LiDAR Quality Assessment Report

CA\NV_Lake-Tahoe_2010

LiDAR generated point cloud acquired in 2010. Five hundred and forty six square mile area encompassing Lake Tahoe CA\NV.

Figure 2. RTK and fast static check point and control monument locations used for Lake Tahoe data acquisition, processing, and accuracy checks

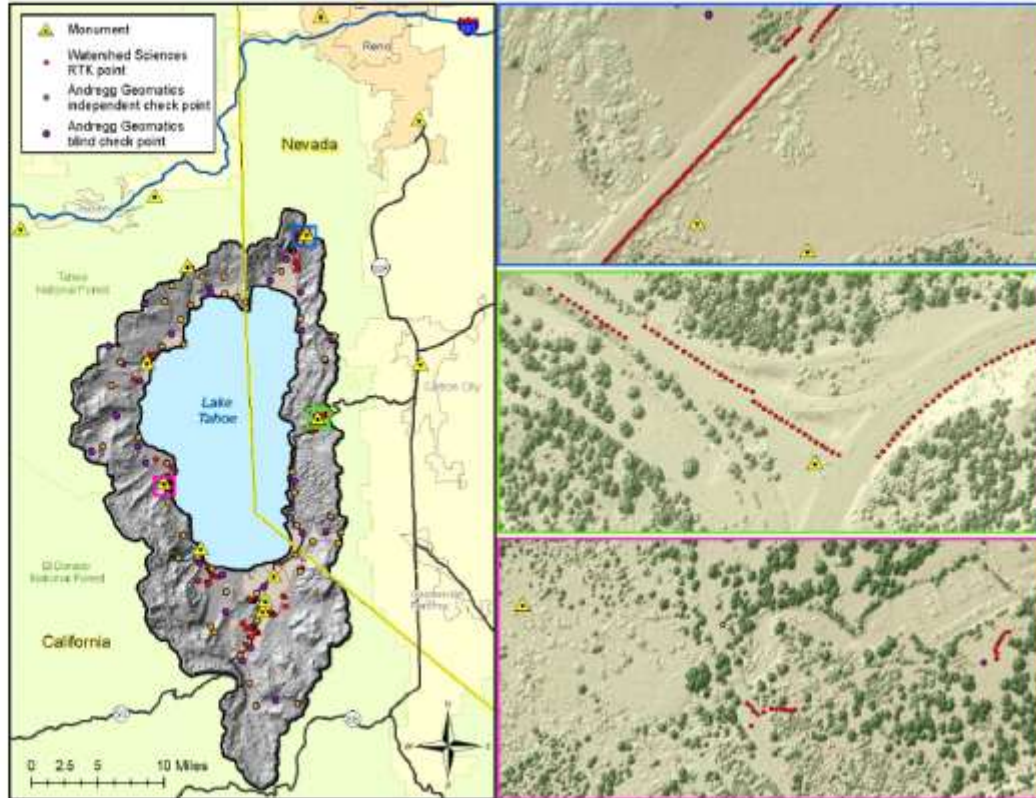
There are a minimum of 20 checkpoints for each land cover class represented. Points within each class are uniformly distributed throughout the dataset. USGS was notable to locate independent checkpoints for this analysis. USGS accepts the quality of the checkpoint data for these LiDAR datasets.
